DRB CASE ACTION LOG - BLUE SHEET

Project #: 100871dp Application #: 11DRB-70212
Project Name: Del Norte Plaza
Agent: Modulus Architects Inc. Phone #:

**CITY OF ALBUQUERQUE
PLANNING DEPARTMENT
December 7, 2011
DRB Comments**

CITY OF ALBUQUERQUE
PLANNING DEPARTMENT
DEVELOPMENT REVIEW BOARD

PASEO DEL NORTE
 VARIABLE WIDTH R/W - ACCESS SITE PLAN FOR SUBDIVISION

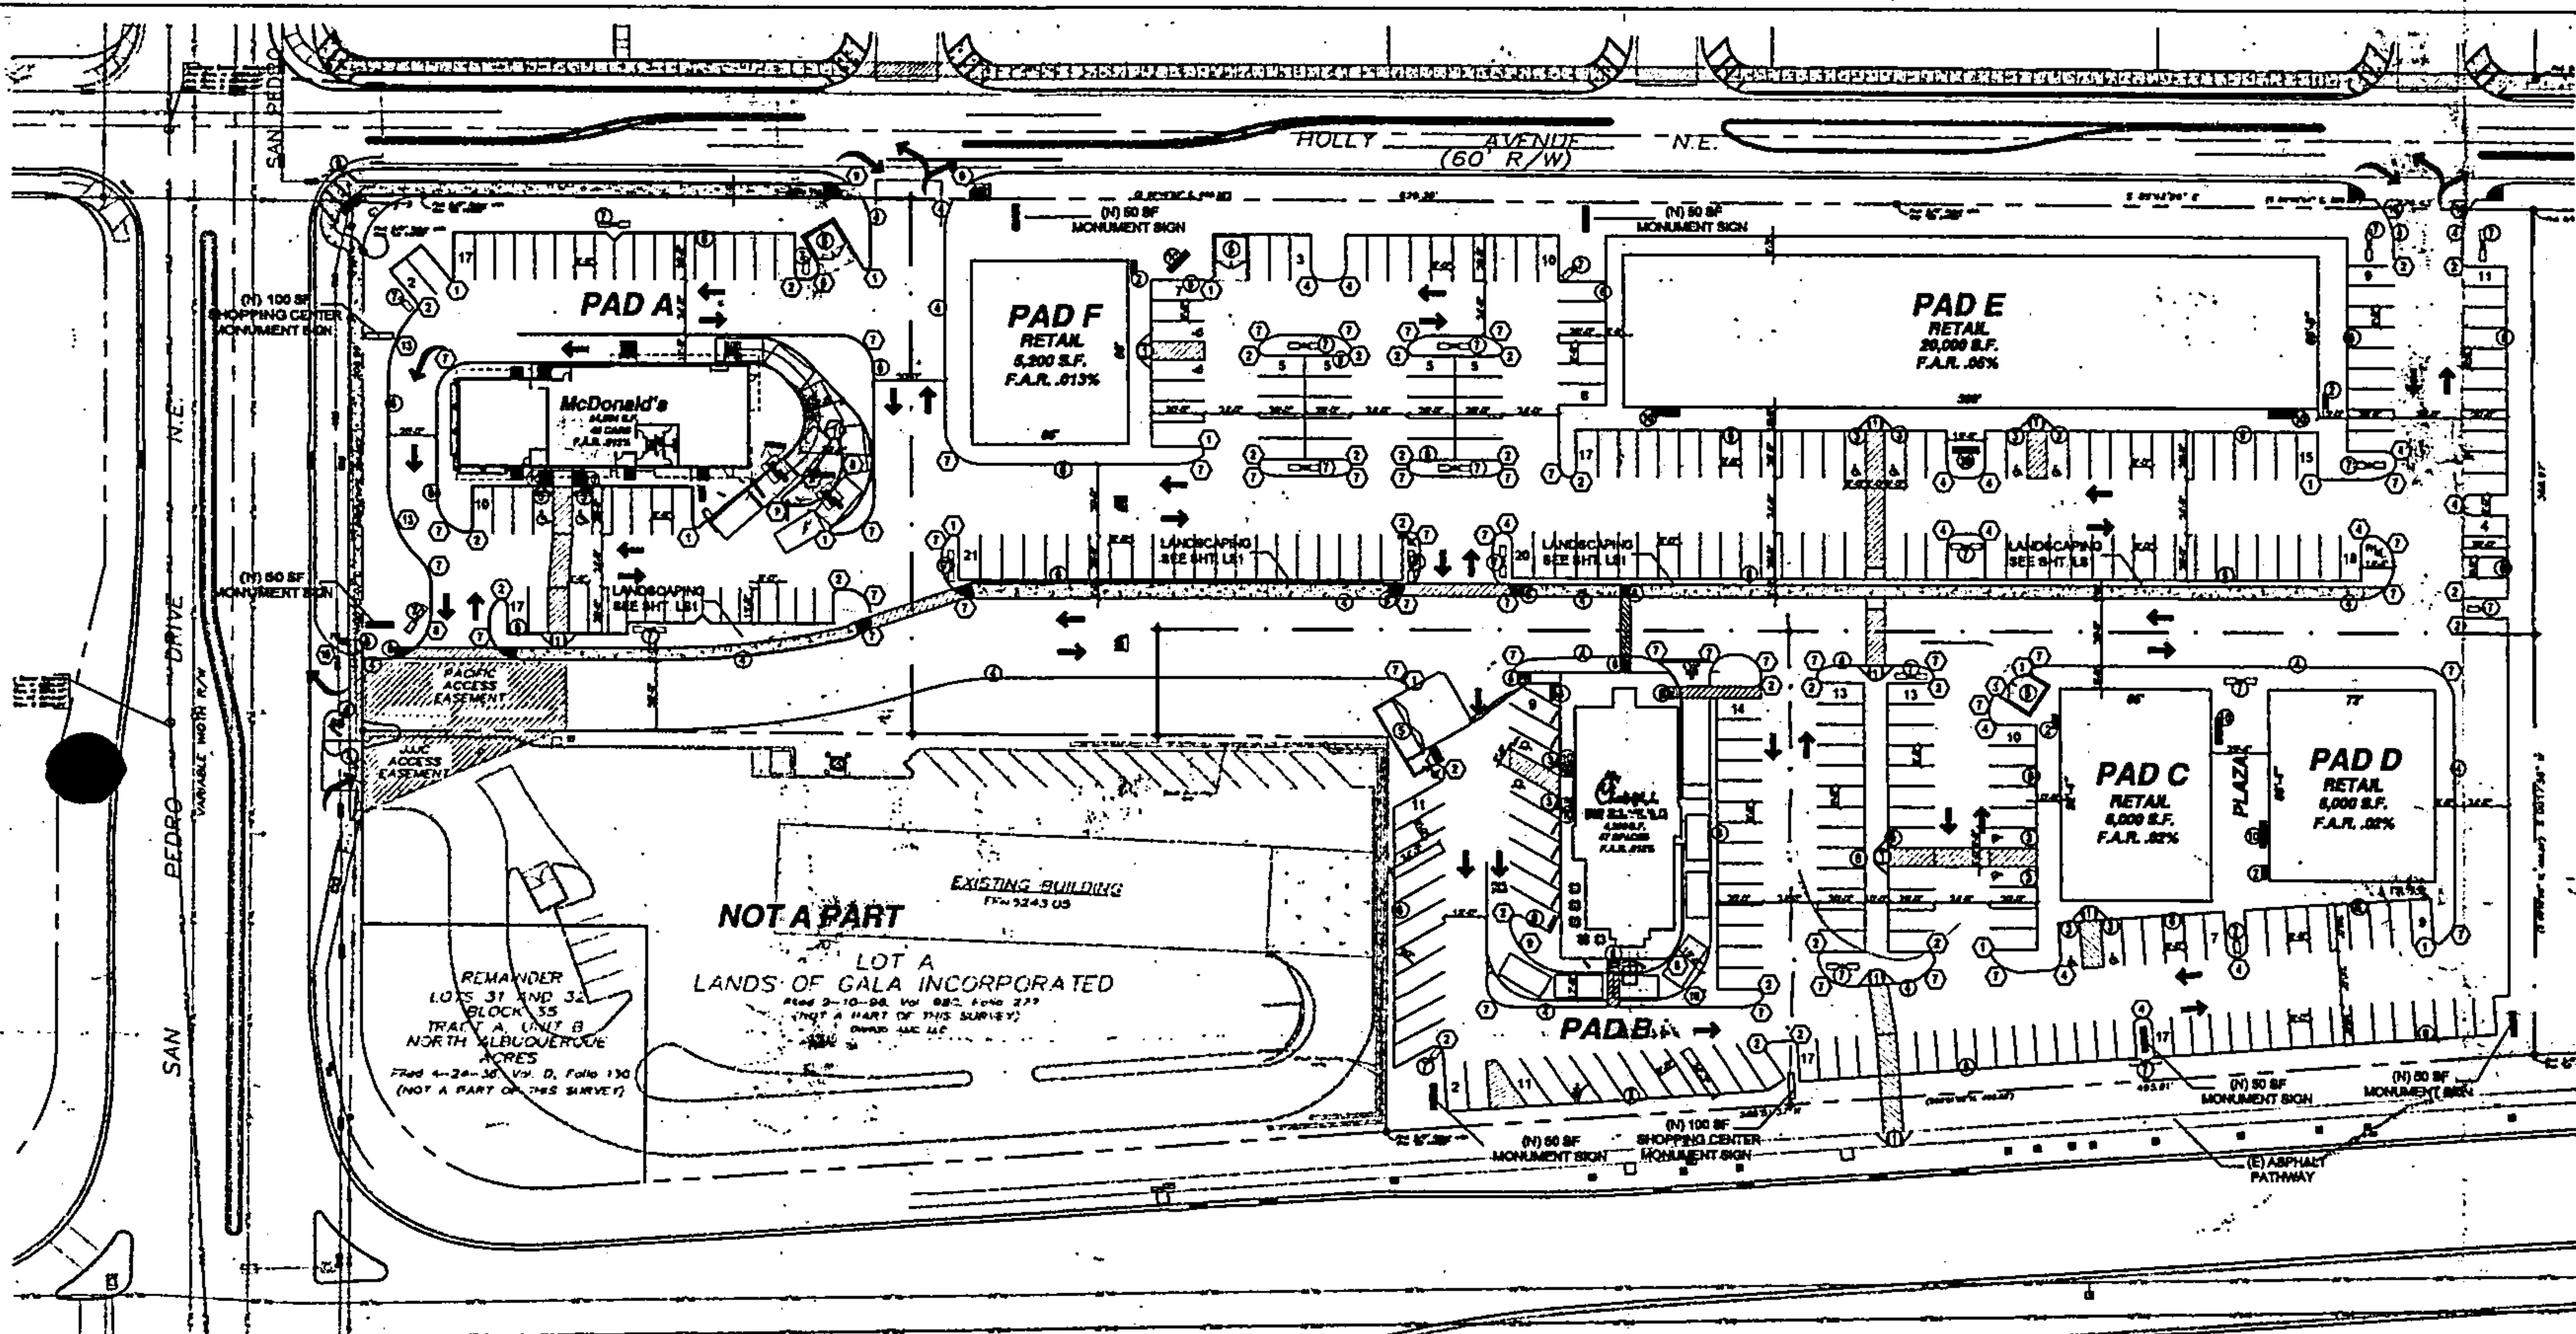
Define all easements and provide recording information.

The access easement referred to on the plan has a recorded date of 03-05-2008; however, the *Common Operation and Reciprocal Easement Agreement for Pacific Paseo* has a recorded date of 05-20-2009. Please revise.

The access easement shown on the site plan does not match the pathway defined as the “Circulation Drive” within the *Common Operation and Reciprocal Easement Agreement for Pacific Paseo* (recorded 05-20-2009).

The Site Plan for Subdivision also has a notation defining the plan as the “Site Plan for Building Permit.” This notation must be removed.

PASEO DEL NORTE
 (VARIABLE WIDTH R/W - ACCESS CONTROLLED)
SITE PLAN FOR BUILDING PERMIT
 SCALE: 1"=20'

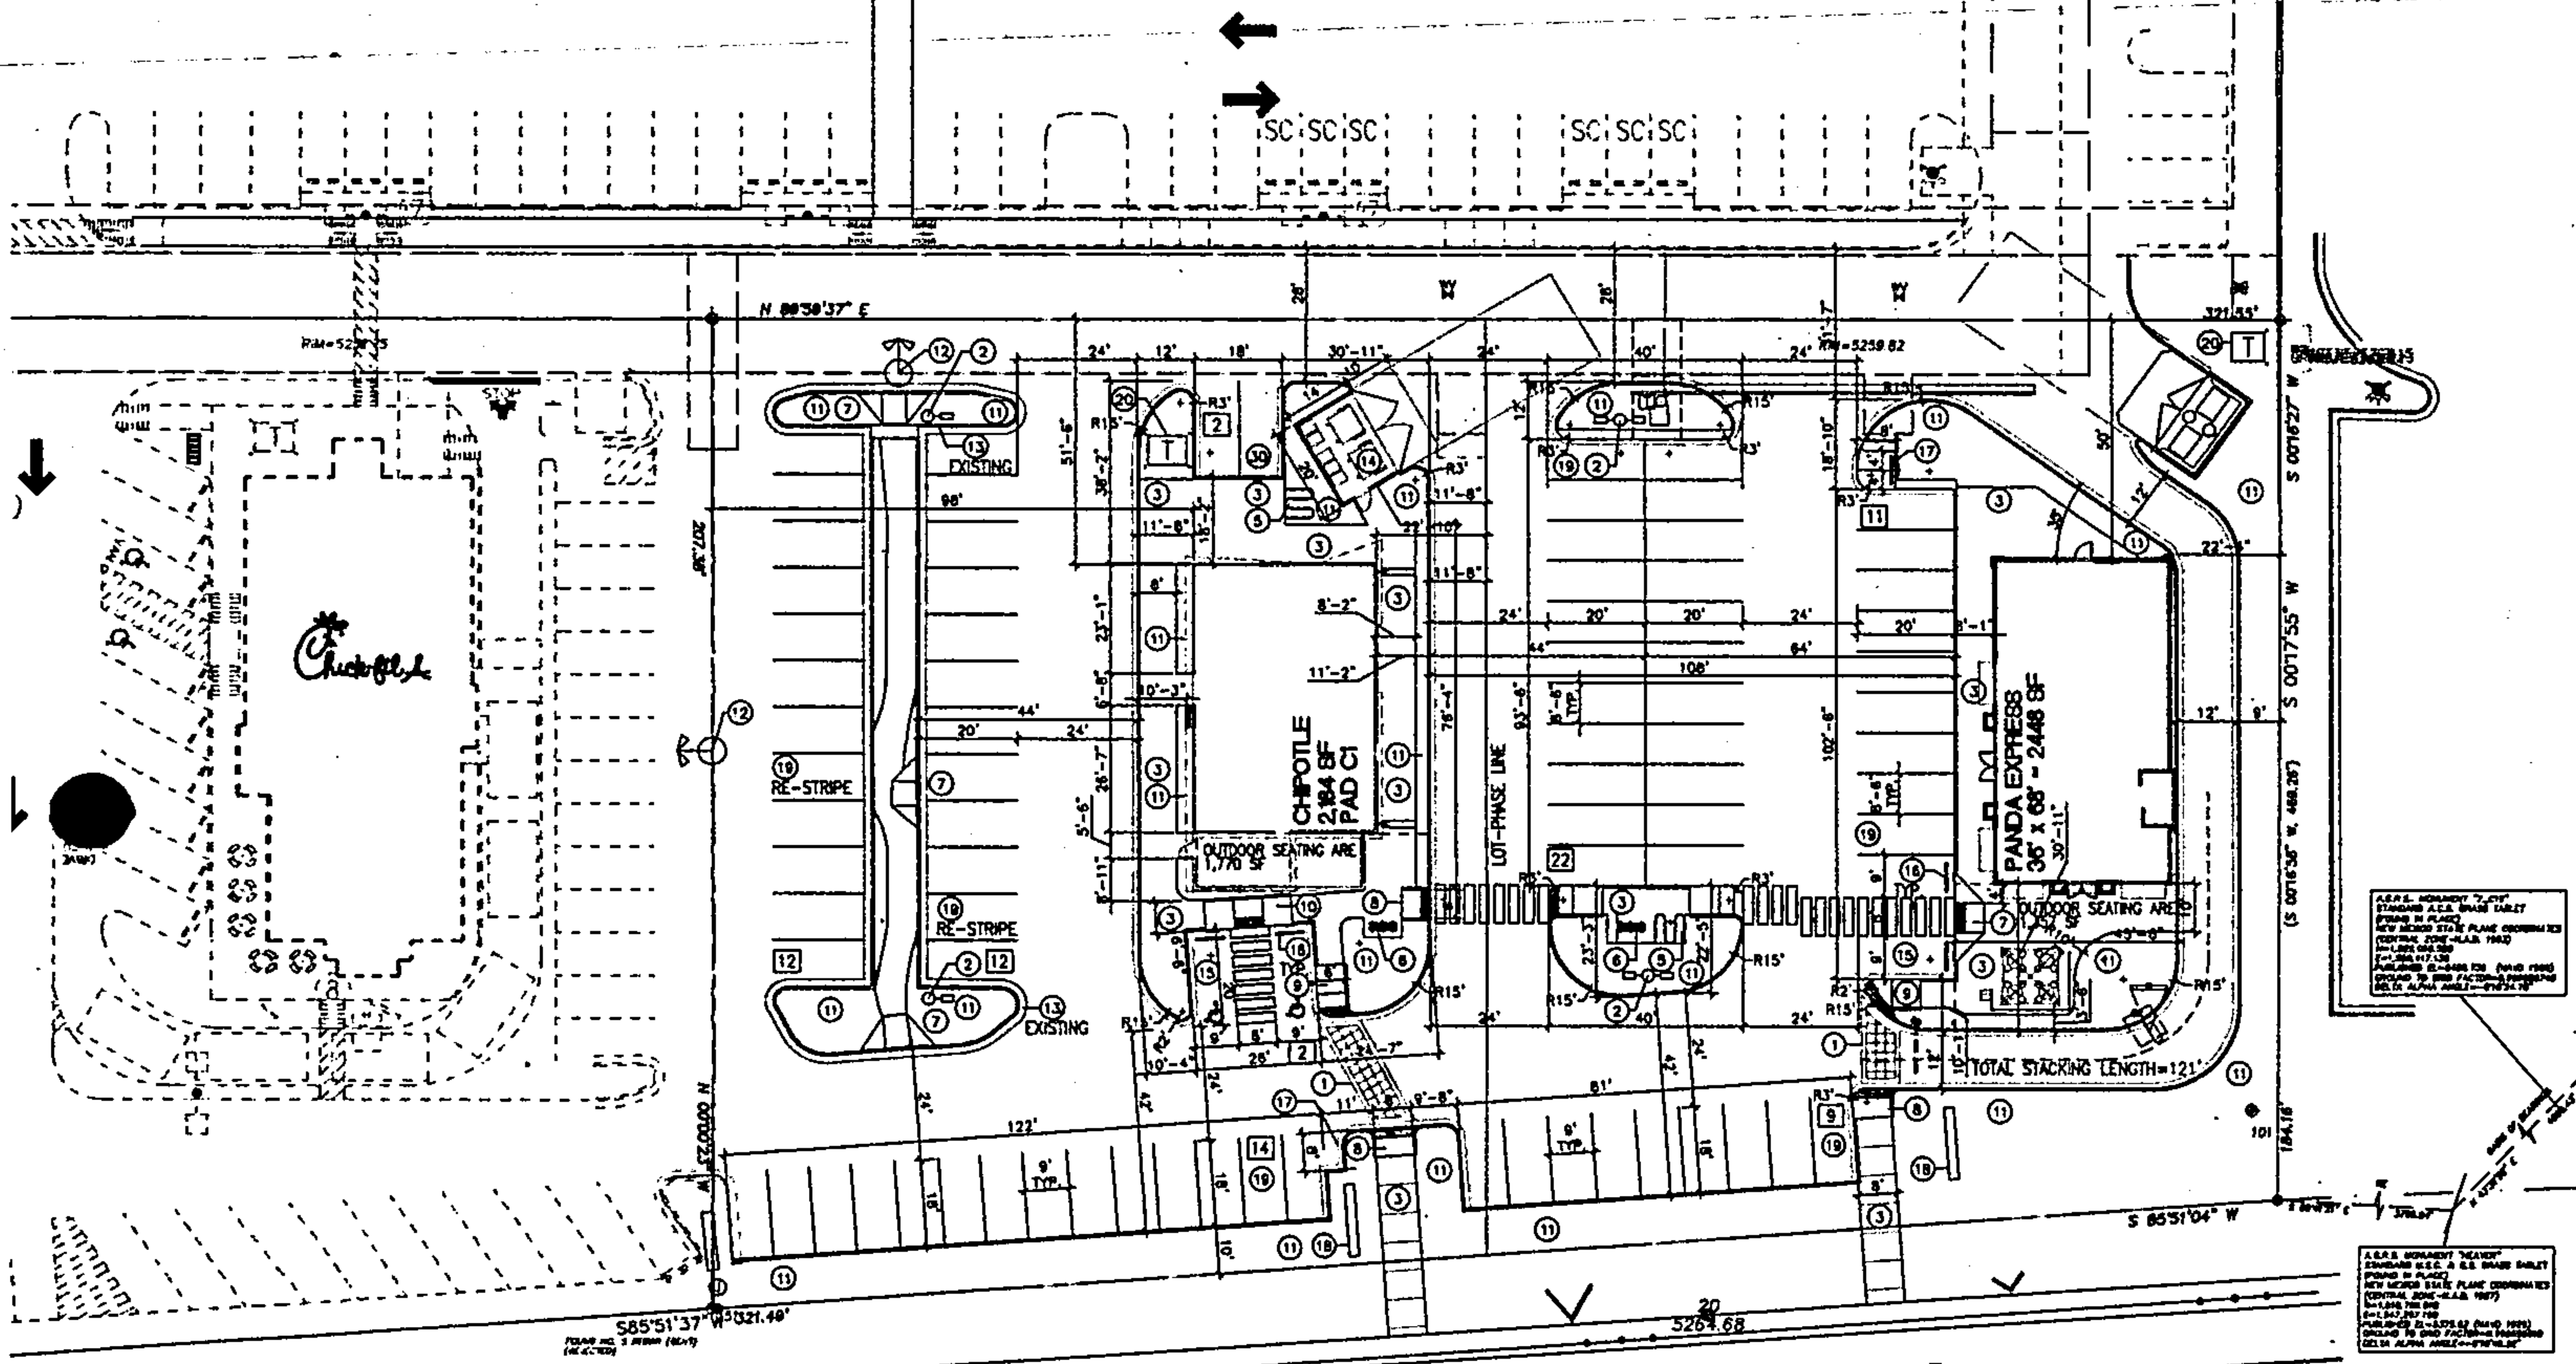
- Define all easements and provide recording information.
- Call out the width of all sidewalk.
- Define all radii.
- The previously approved site plan showed pedestrian interconnectivity between Pad E and Pad C. However, the proposed changes appear to remove the ADA pathway from Pad E to the roadway. This connection must be maintained.

Pedestrian connection from Paseo del Norte path to the western parking aisle must be provided for Pad E per approved site plan. This and the pedestrian connection between buildings needs to be textured concrete also.

- The access easement referred to on the plan has a recorded date of 03-05-2008; however, the *Common Operation and Reciprocal Easement Agreement for Pacific Paseo* has a recorded date of 05-20-2009. Please revise.
- The access easement shown on the site plan does not match the pathway defined as the “Circulation Drive” within the *Common Operation and Reciprocal Easement Agreement for Pacific Paseo* (recorded 05-20-2009).
- Call out the width of all sidewalk.
- The vicinity map does not clearly indicate the site location.
- Provide appropriate “Do Not Enter” signing and striping at the exit of the drive through.
- Detail 12 (Sheet A1.1) does not define the maximum slope of the ramp.

16 CURBED H.C RAMP
Scale: N.T.S.

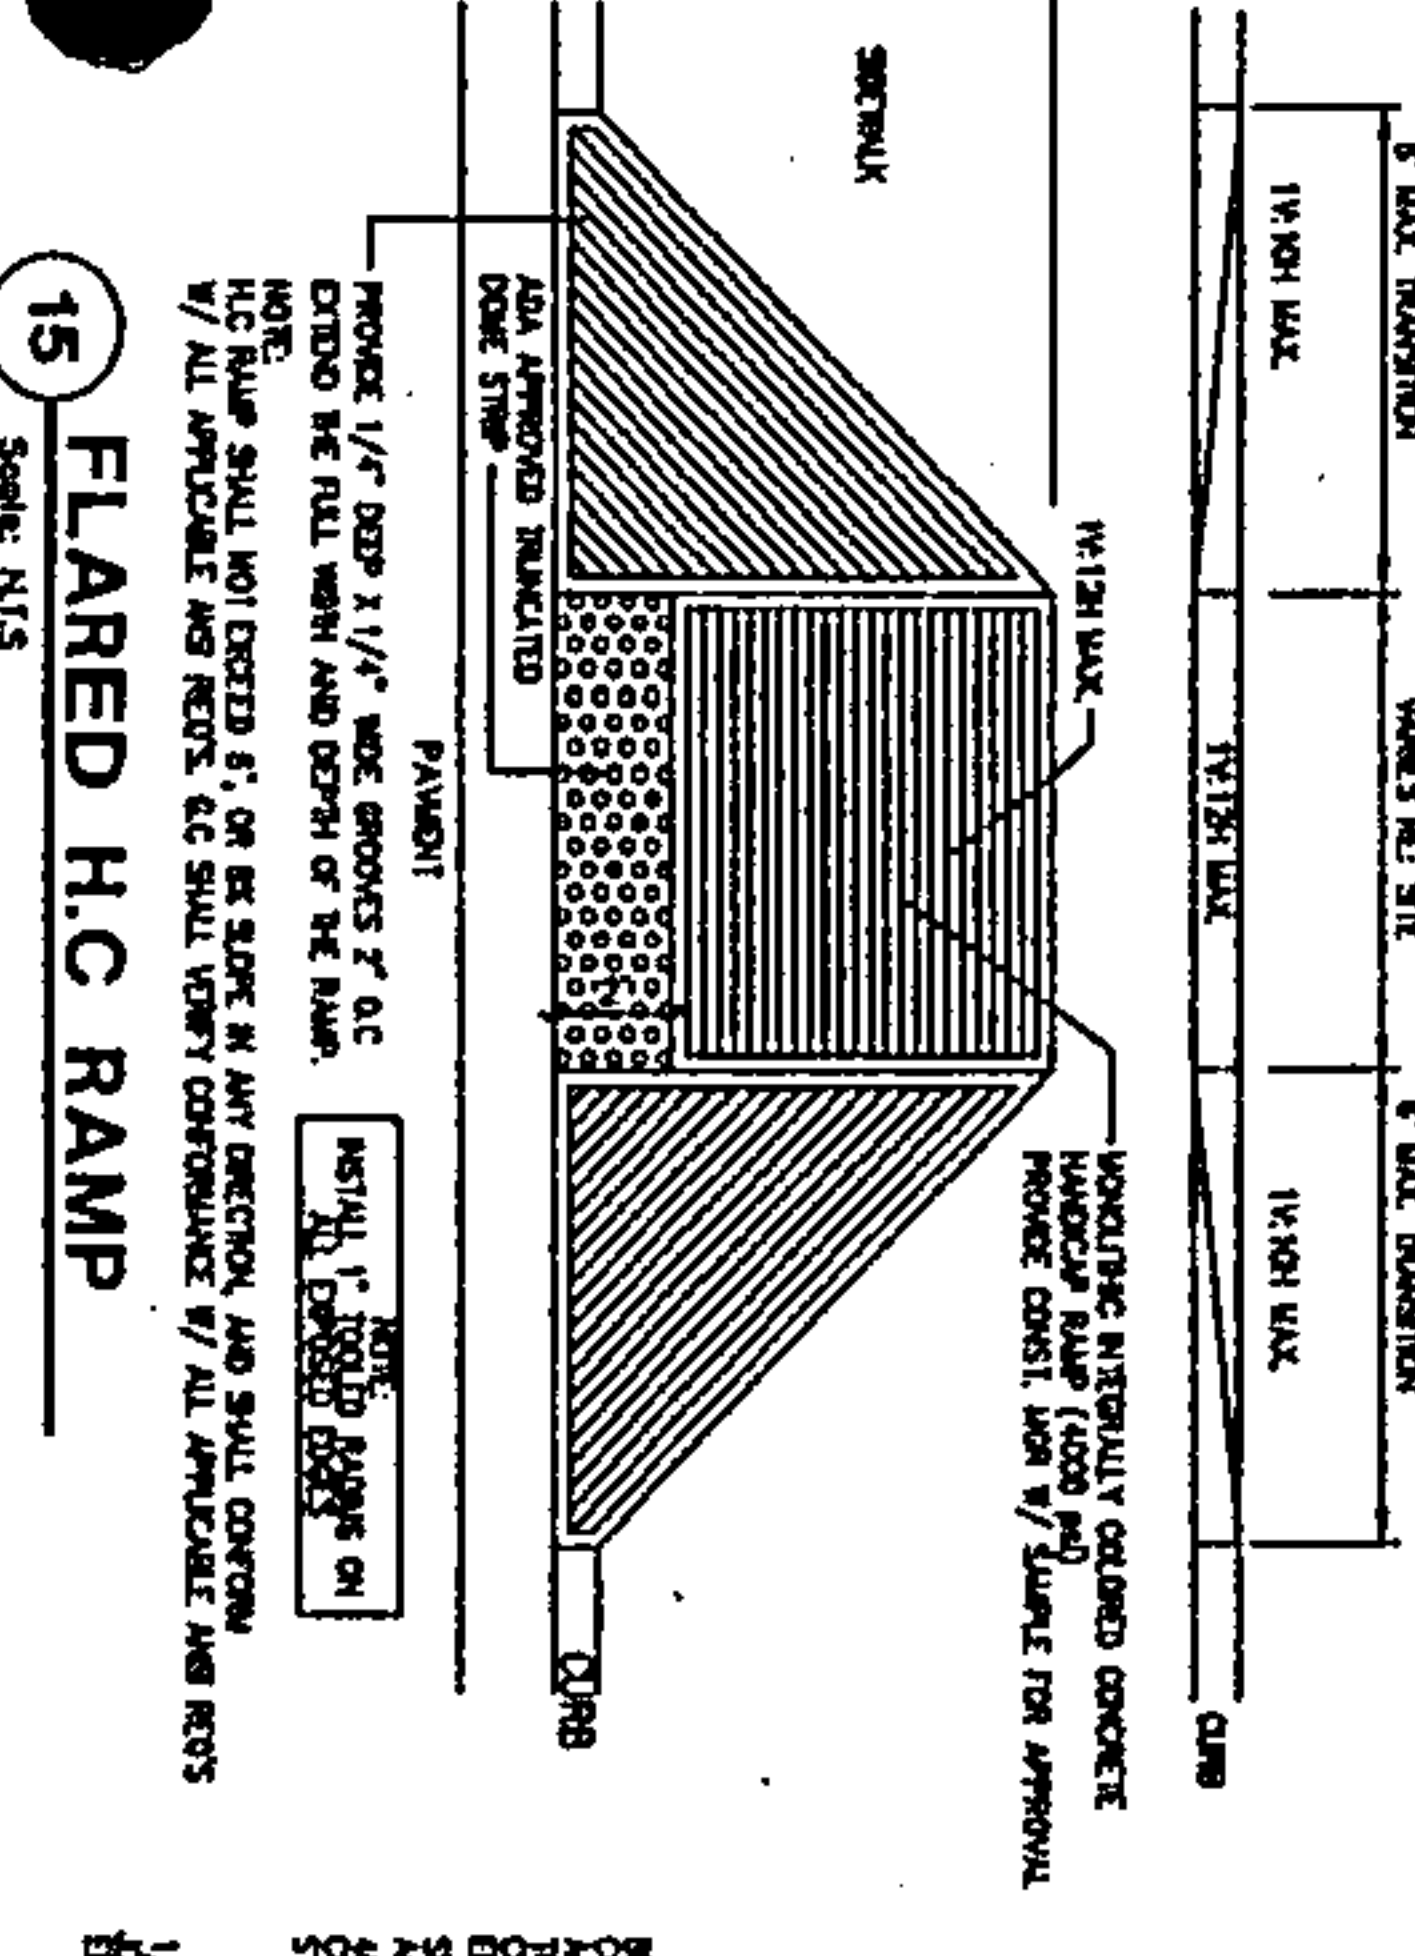
- Detail 16 (Sheet A1.1) does not define the maximum slope of the ramp.
- Detail 12 (Sheet A1.1) does not define the maximum slope of the ramp.
